ADDENDUM #1

Project Name:
DOC MPCF Bldg 20 Plumbing Replacement
DAS# 9372.00
RFB 937200-02
Addendum #1
Dated: July 29, 2025

E2 FC103 ELEVATION
1 1/2" = 1'-0" 1'

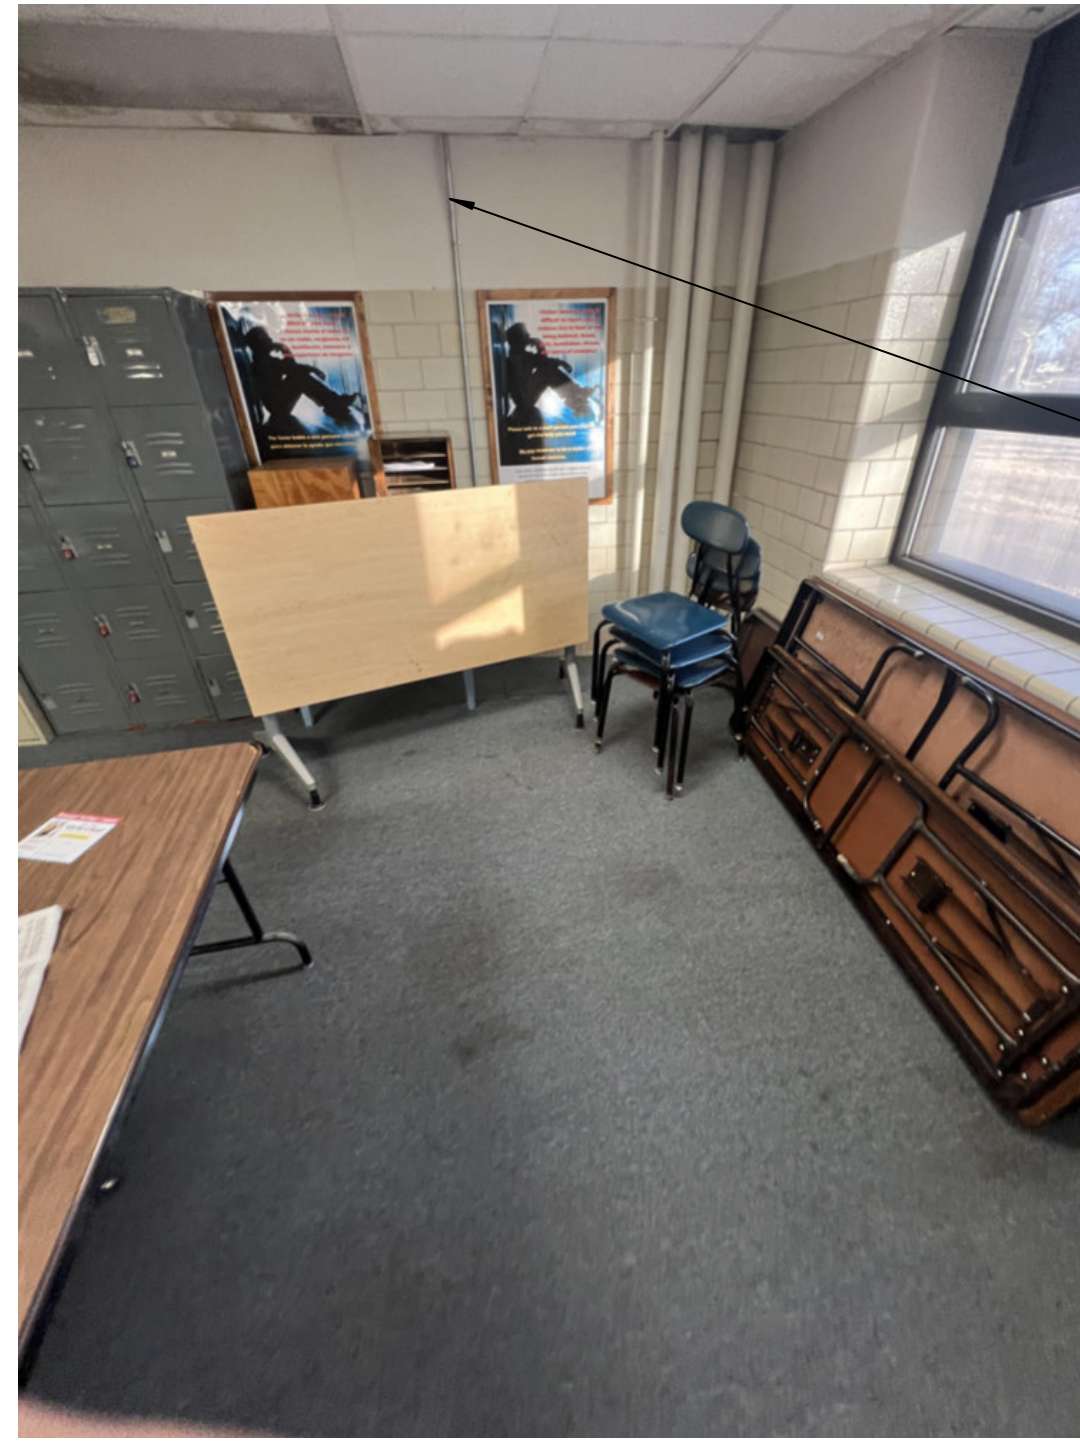
REMOVE EXISTING SURFACE
MOUNTED CONDUITS/WIRING,
OUTLETS, JUNCTION BOXES,
ETC. FROM EXISTING WALL
AND INSTALL ON NEW CHASE
WALL. REFER TO DRAWINGS
PD111A, PD111B, PD112A,
PD112B AND PD113A FOR
ADDITIONAL INFORMATION.

A2 FC201 ELEVATION
1 1/2" = 1'-0" 0' 1"

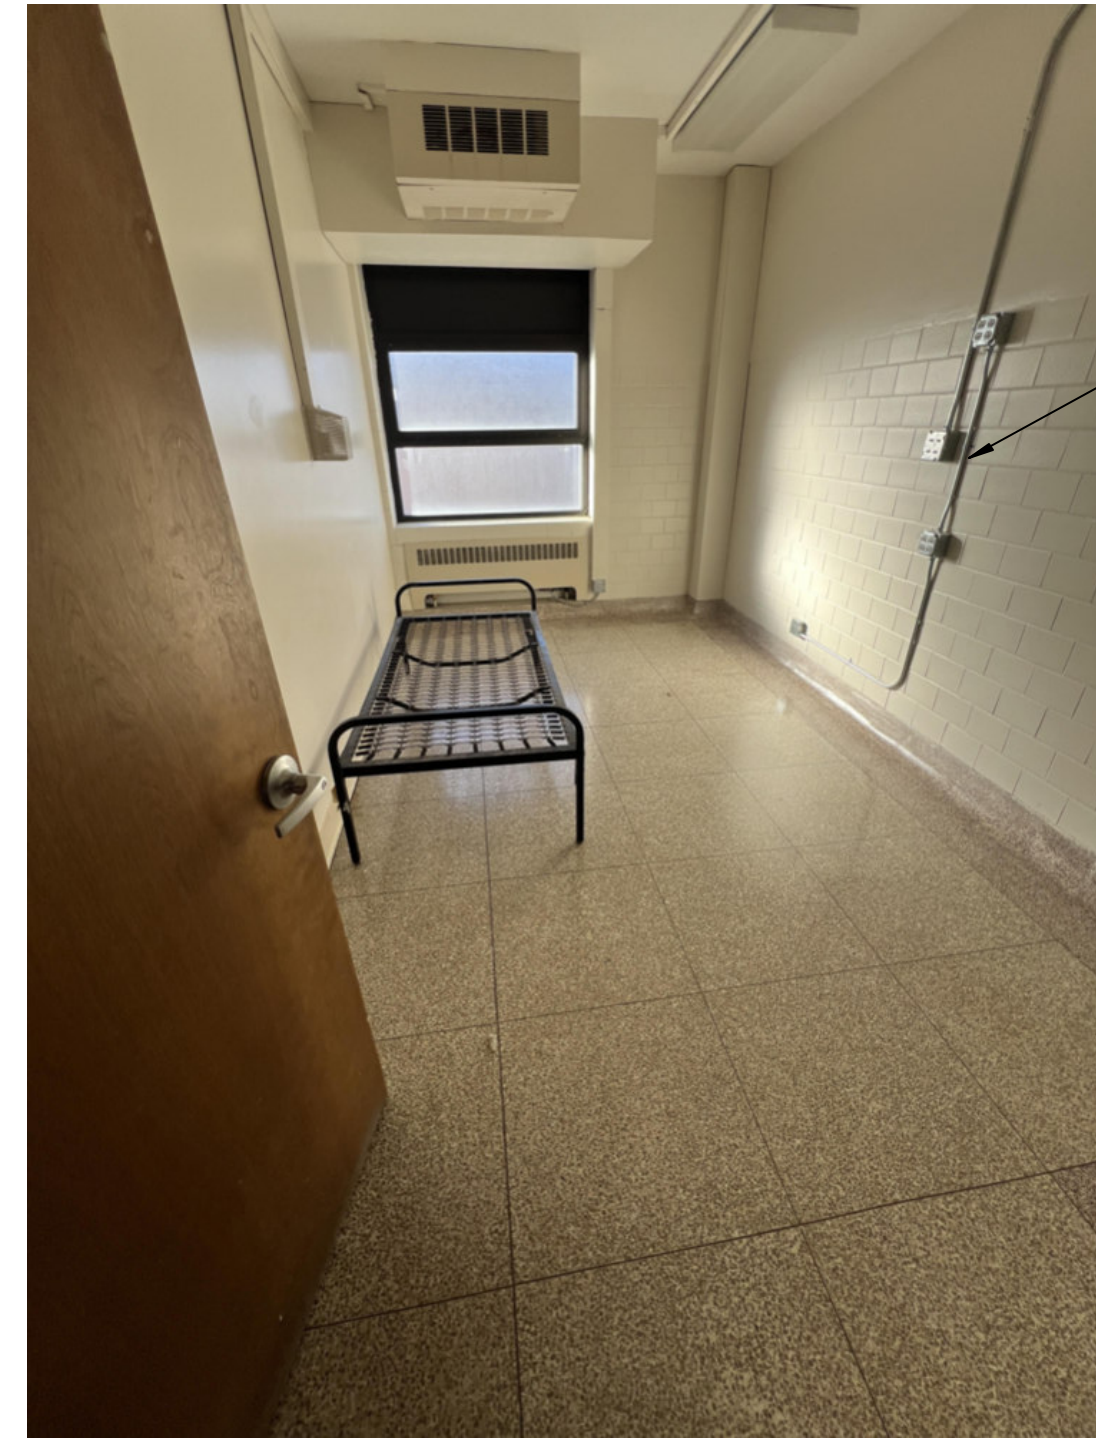
REMOVE EXISTING SURFACE MOUNTED CONDUITS/WIRING, OUTLETS, JUNCTION BOXES, ETC. FROM EXISTING WALL AND INSTALL ON NEW CHASE WALL. REFER TO DRAWINGS PD111A, PD111B, PD112A, PD112B AND PD113A FOR ADDITIONAL INFORMATION.

E2 S211 ELEVATION
1 1/2" = 1'-0" 0' 1"

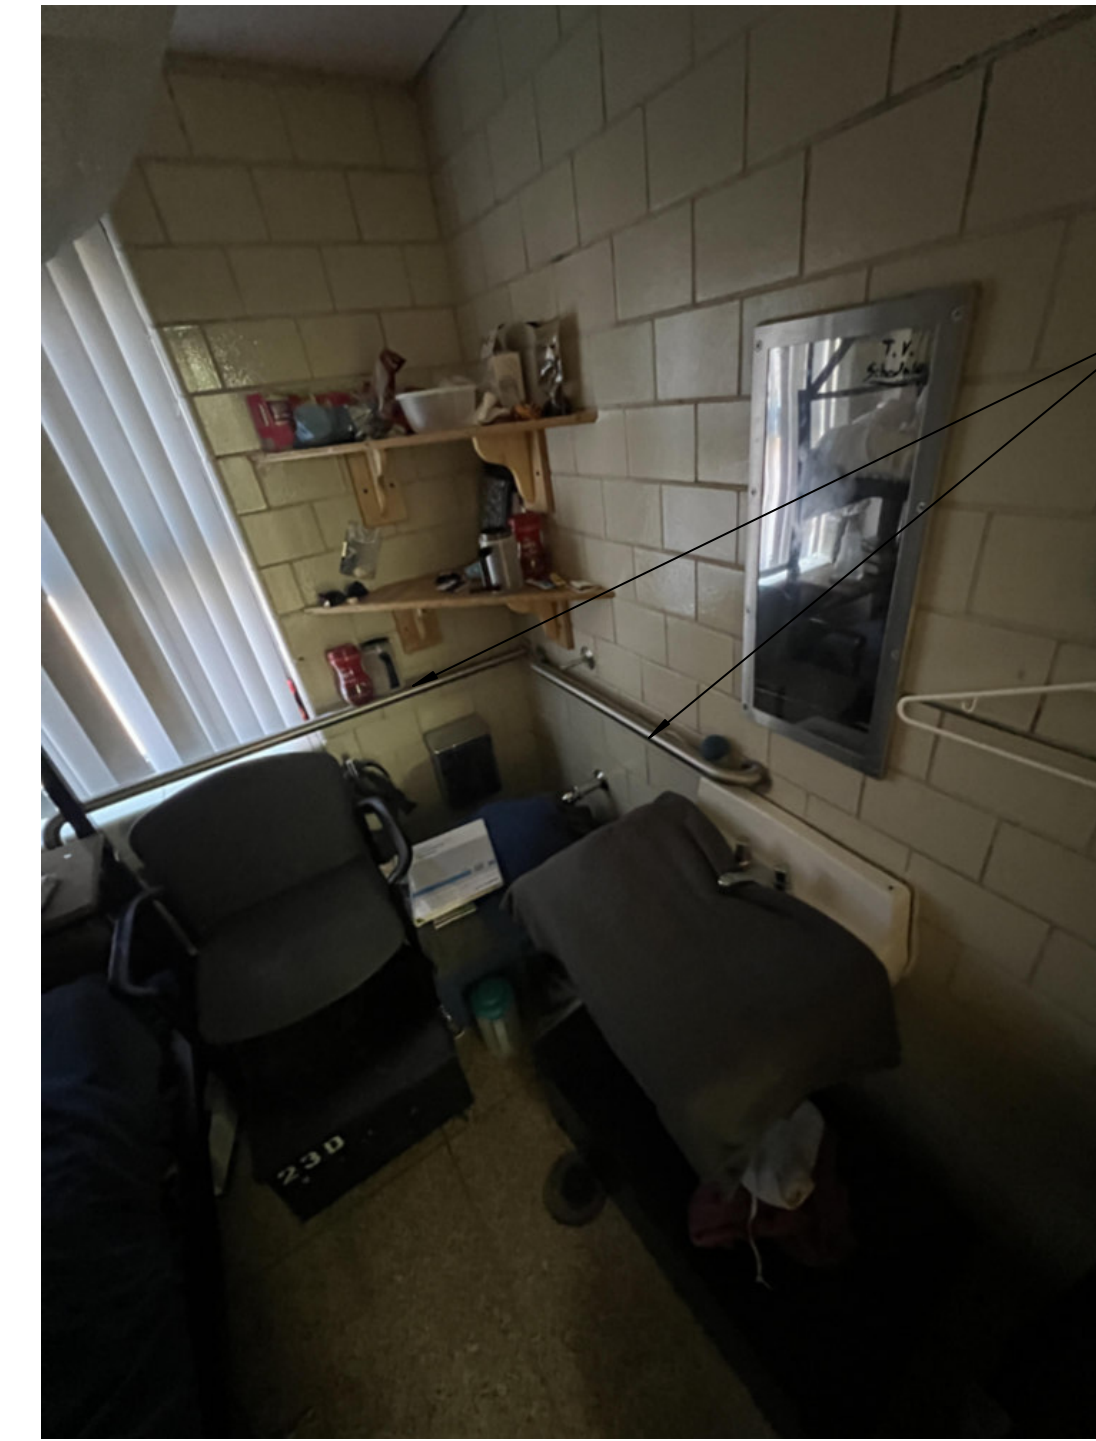
- H. For areas that have multiple runs of conduits but the photos/arrows only point to 1 – do we account for the other conduits or just the 1? (ex. E2/A211)

- M. Would need location of where to move conduits. Has conduit going horizontally. (see E2/A211)
 - 1. Conduit to be reinstalled in same location on new wall, refer to notes on PD plans.

- 1. Generally yes, all conduit shown in the photo needs to be revised. In the example E2/A211 though, only a portion of the existing wall is being removed/replaced (crosshatched area) so only conduit that is affected by the wall removal needs to be addressed.

M1

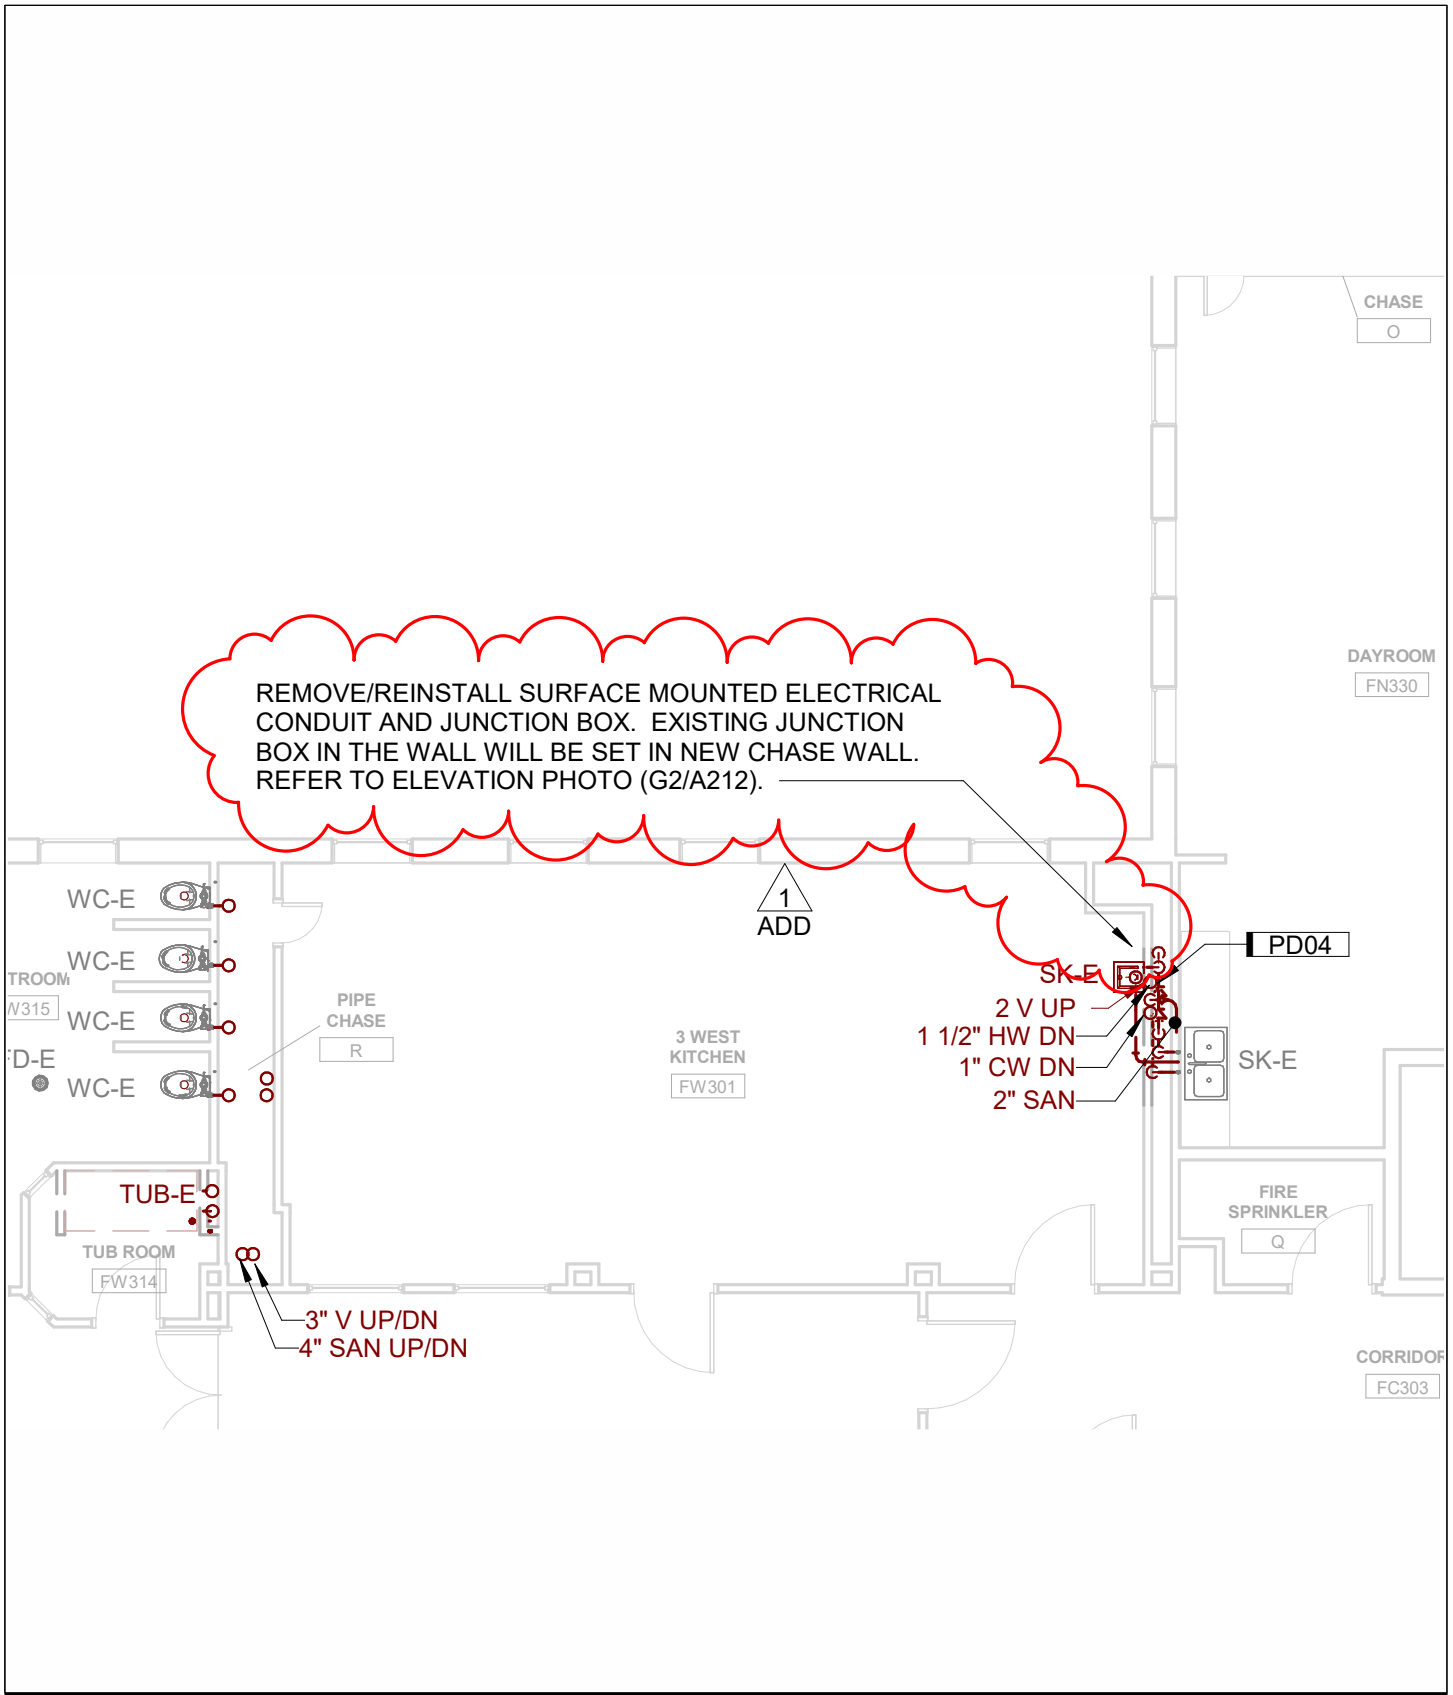
- A. Please see the new sheets M1 & M2 for electrical clarifications.
- B. Sheet P114 keynote P18 states ‘capped existing to remain vent thru roof’.
- C. Please see answers to questions submitted in section 3 – questions & clarifications.
- D. Please see updates to sheet A210, A211 & A212.
